SUBJECT: SUMMARY OF THREE APRIL 2002 CONFERENCE CALLS WITH THE
LICENSEE ON THE REACTOR PRESSURE VESSEL HEAD INSPECTION
PLANS AND RESULTS AT ARKANSAS UNIT ONE, UNITS 1 AND 2 (ANO-1&2)
(TAC MB4525)

ANO-2 RV Head Inspection Summary for 2R15

ANO-2 PV Head Plan View

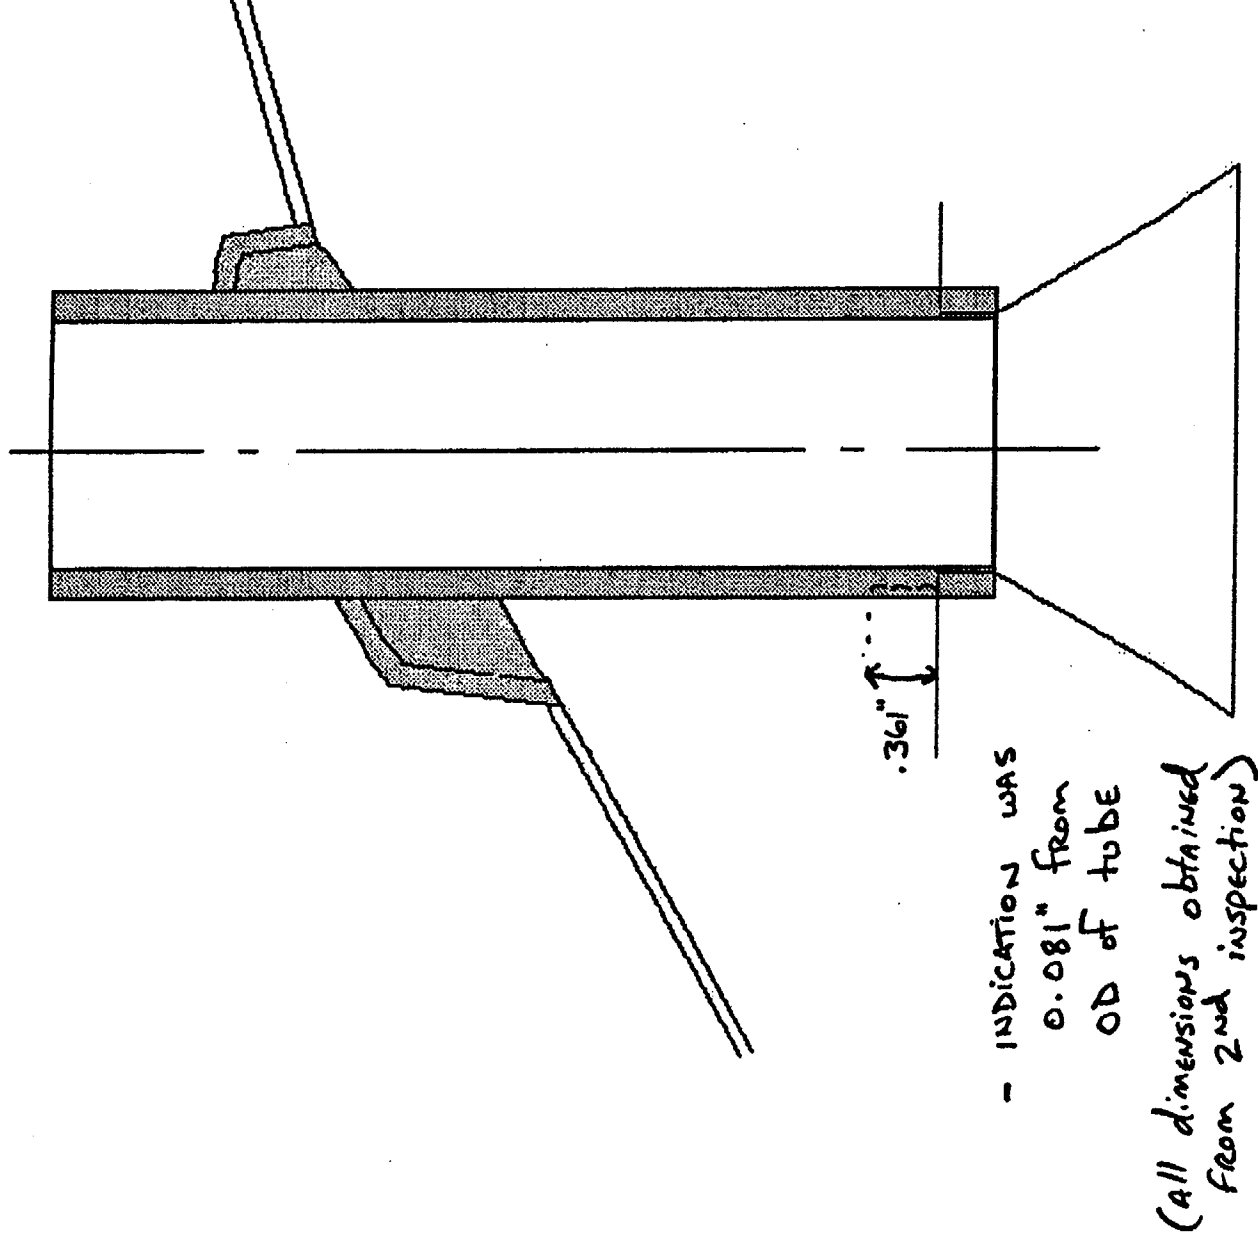
- All 90 head penetrations were confirmed to have pressure boundary integrity with no indications of PWSCC cracking and no through wall leaks that could cause head wastage.
- Additional NDE was performed on three CEDMs from under the head (see diagrams)
 - Nozzle 43 and 59 had J- weld reflections at the low side of the nozzles (~0°) that were further inspected by PT and found to have no surface indications found.
 - Nozzle 30 had indications in the nozzle just above the threading for the CEDM guide cone. An ECT was performed on the OD of the nozzle with no surface indications found.
- No signs of leakage were detected above the head on the insulation. Only very minor occasional boric acid staining observed (likely from historical venting).
